## Product Change Notice (PCN)

**PCN Number:** PCN-0450994R-01

SJ1-3553NG, SJ1-3554NG, SJ1-3555NG, & SJ1-3555NG-BE

Description of Change:

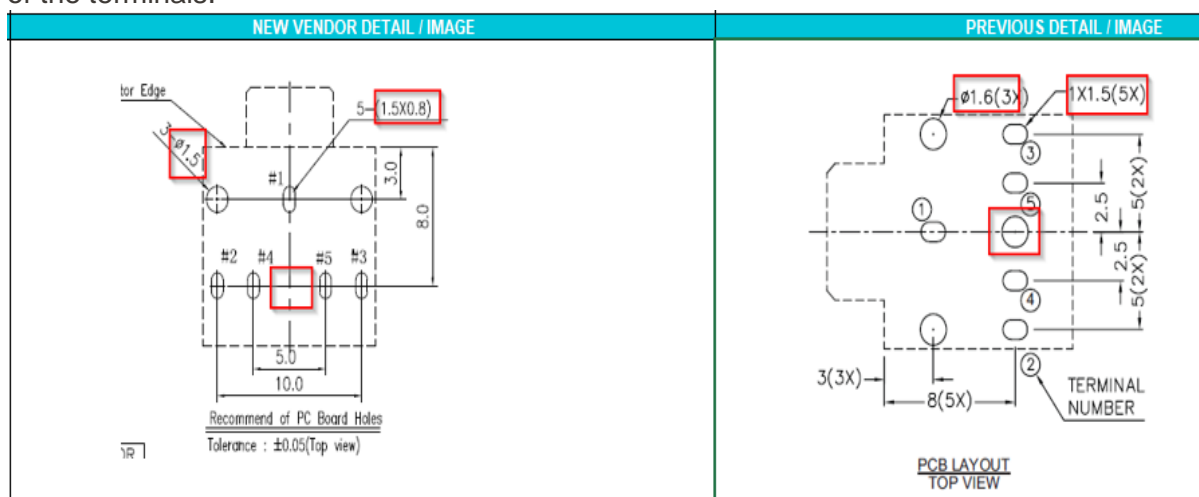
1. PCB hole recommendation differs, image does not have location feature in the back row of the terminals.

2. Terminals, and housing materials have changed

NEW VENDOR DETAIL / IMAGE				PREVIOUS DETAIL / IMAGE		
ITEM	DESCRIPTION	MATERIAL	PLATING/COLOR		MATERIAL	PLATING
1	contact foot	C2680	tin over nickel	terminal 1	brass	tin
2	contact foot	C5191	tin over nickel	terminal 2	copper alloy	tin
3	contact foot	C5191	tin over nickel	terminal 3	copper alloy	tin
4	contact foot	C2680	tin over nickel	terminal 4	brass	tin
5	contact foot	C2680	tin over nickel	terminal 5	brass	tin
6	housing	PBT (UL94V-0)		plastic	PBT	
7	cover	PBT (UL94V-0)
